## TEXAS COMMISSION ON ENVIRONMENTAL QUALITY

Re: Edwards Aquifer, Comal County  
NAME OF PROJECT: Metamorphic Design; located at 18636 Forty-Six Parkway, Bulverde, Texas  
TYPE OF PLAN: Request for the Approval of a Contributing Zone Plan (CZP); 30 Texas Administrative Code (TAC) Chapter 213 Subchapter B Edwards Aquifer  
Edwards Aquifer Protection Program San Antonio File No. 232.01; Investigation No. 826029  
Regulated Entity No. RN105187652; Additional ID 13-07021306

**RE:** Metamorphic Design CZP (EAPP No. 232.01)  
Response to Additional Comments

Re: Metamorphic Design Contributing Zone Plan (CZP)  
Edwards Aquifer Protection Plan (EAPP) No. 232.01  
Response to Notice of Deficiency (NOD)

**VORTECH - PLAN VIEW**

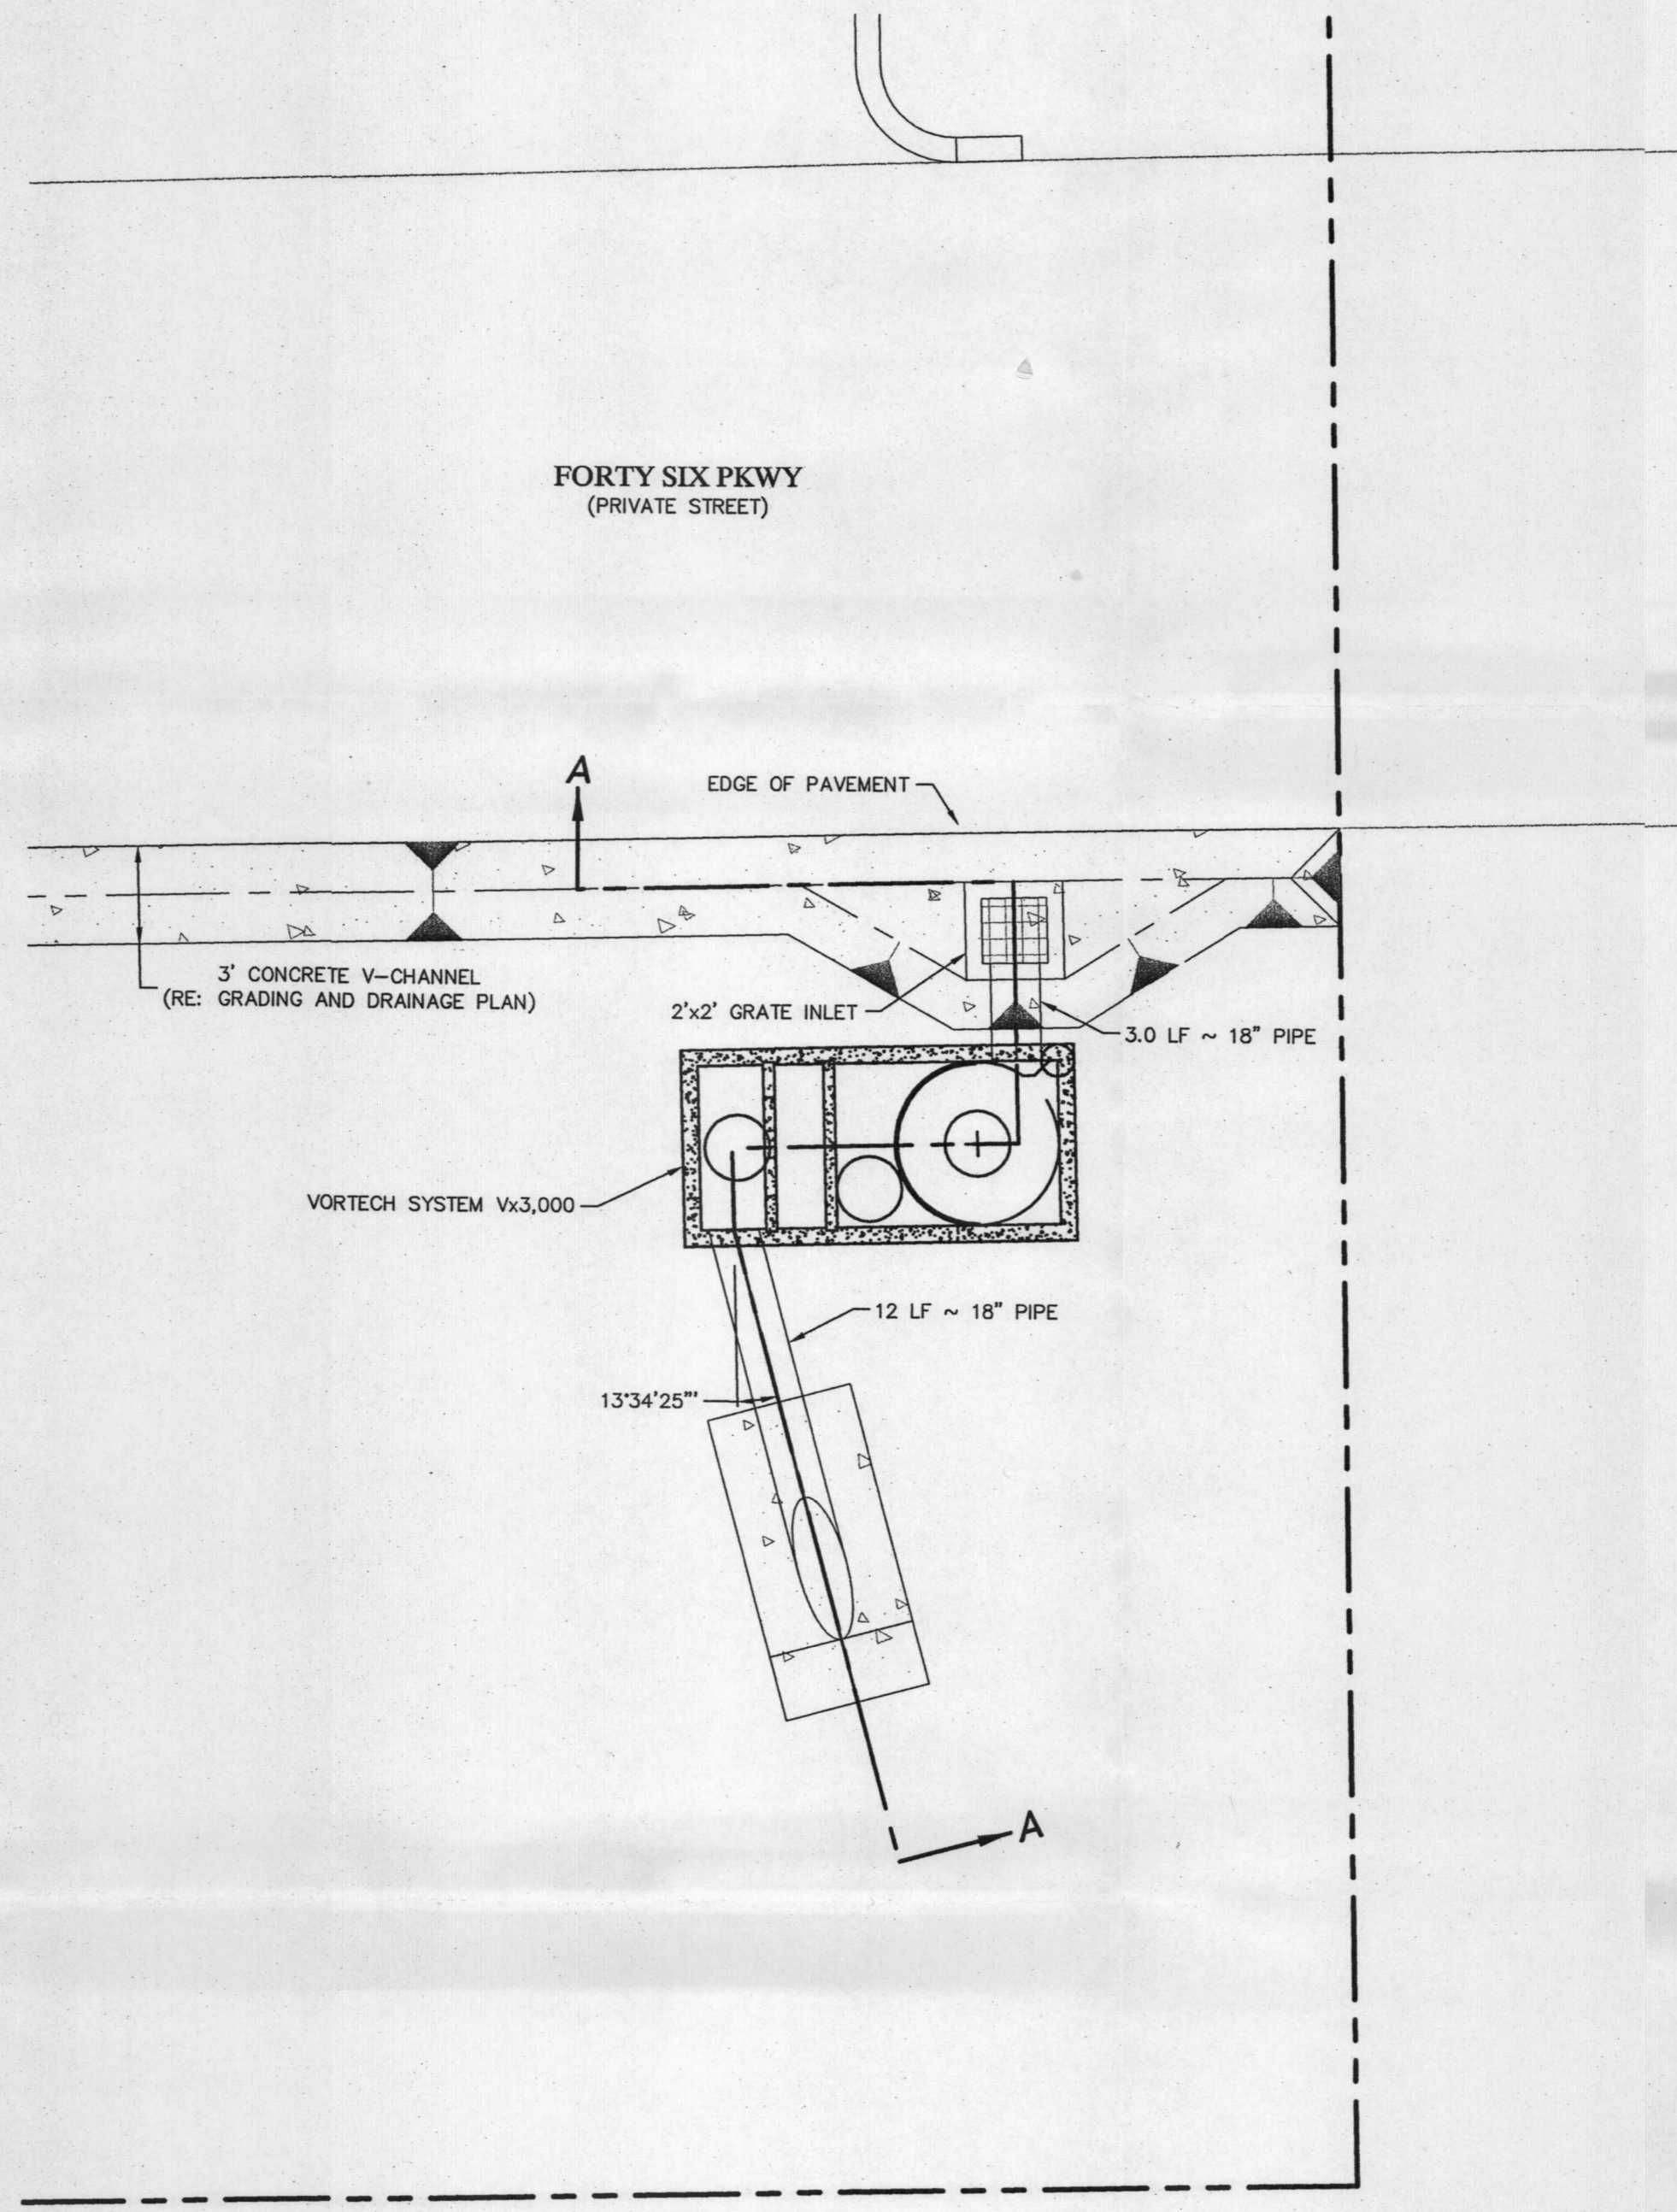
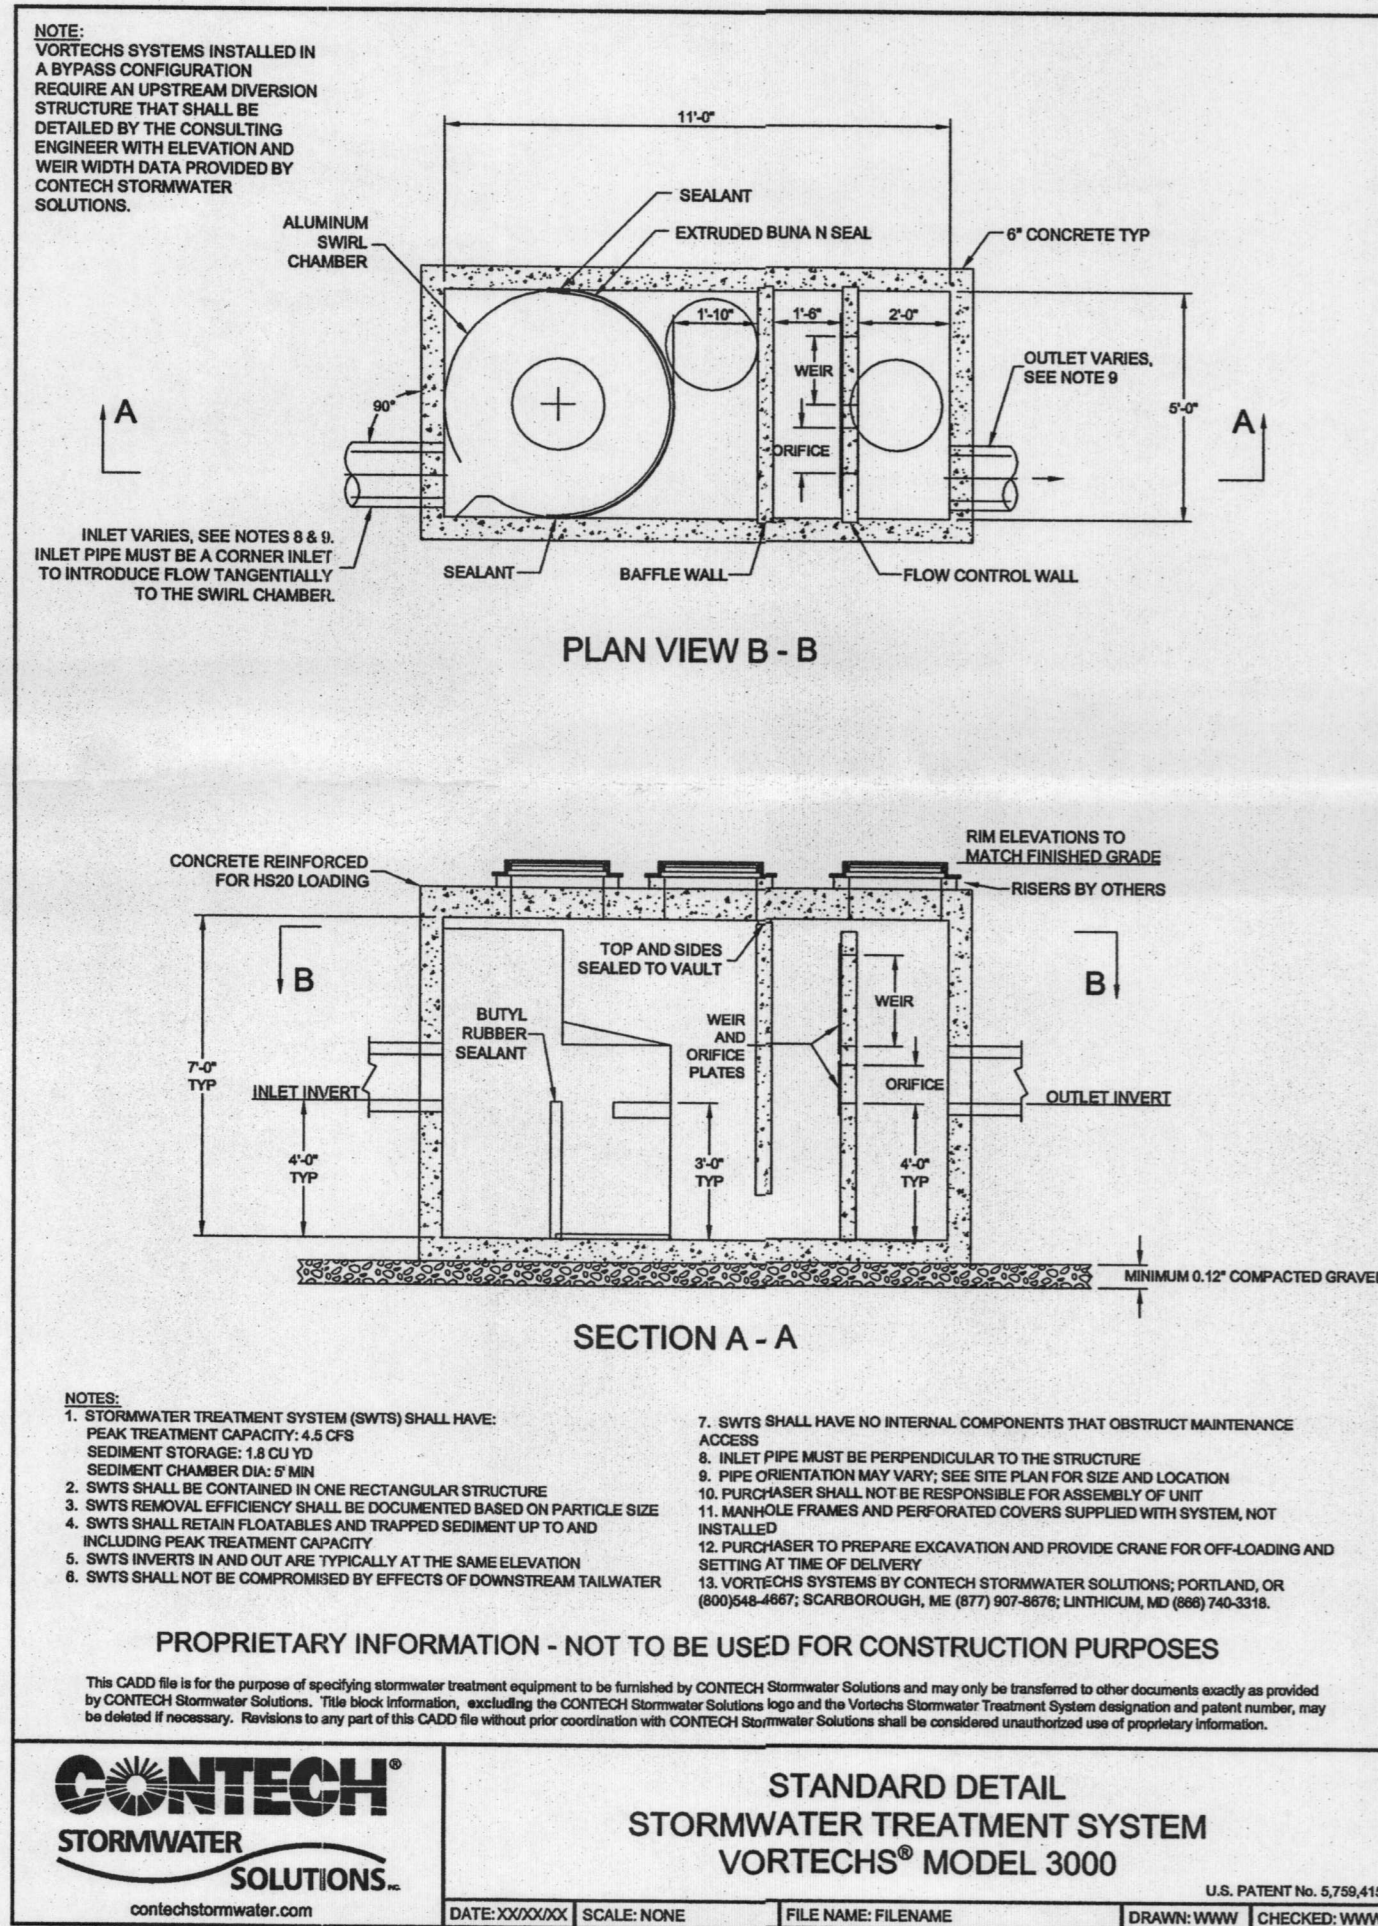
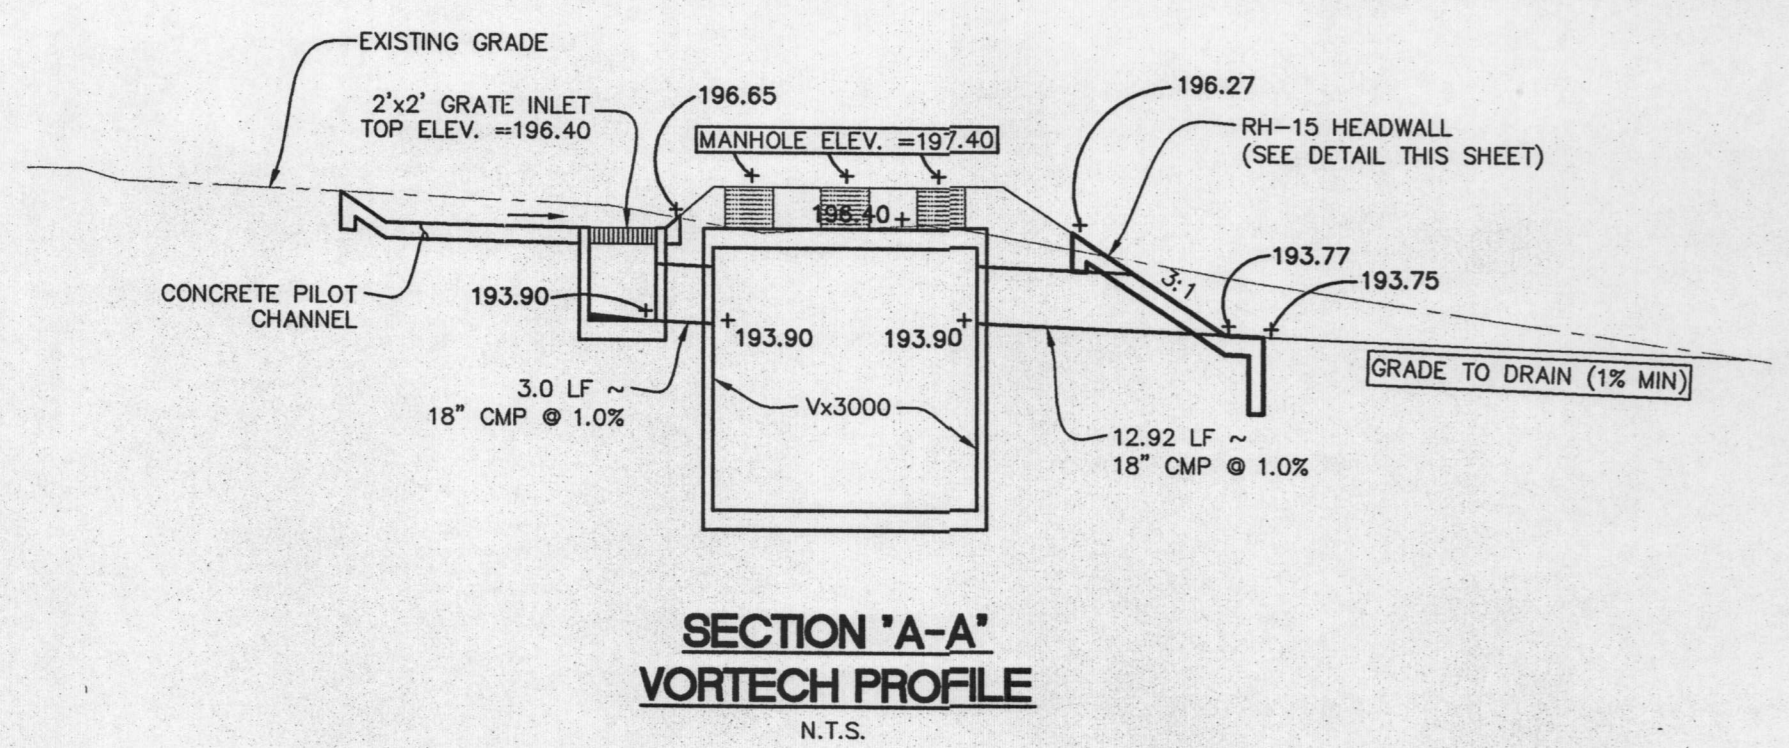
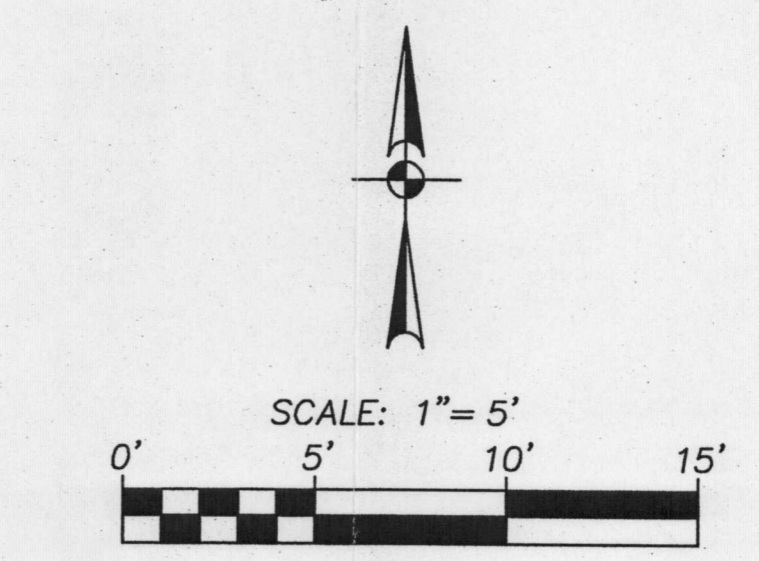
- d. Annotate where the outfall from the BMP will immediately go.
3. Exhibit 4:
  - a. Per Item 53, as applicable, show where the energy dissipators will be located.

- b. Explicitly show where the BMP's treated effluent will immediately be directed.
  - c. Provide revisions to the proposed BMP for plan and profile views, the standard detail, and design data as necessary.

- a. Per Item 53, as applicable, show where the energy dissipators will be located.
- b. Explicitly show where the BMP's treated effluent will immediately be directed.
- c. Provide revisions to the proposed BMP for plan and profile views, the standard detail and design data as necessary.

*Response:*

- a. *The velocity at the point of discharge is not great enough such that baffle blocks or other energy dissipaters are required; however, the concrete headwall surrounding the discharge pipe from the Vortechs unit will minimize erosion at the point of discharge. Item 53 is not part of the "Site Plan Requirements" (Items 30-41); therefore, no revision is necessary.*
- b. *The outfall from the Vortechs unit is shown on Exhibit 1 and 3. Flow is discharged via pipe to a grassed area at the southern property line. No revision is necessary.*

- c. *Please see the response to "2.a" of the TCEQ-10257 comments below.*
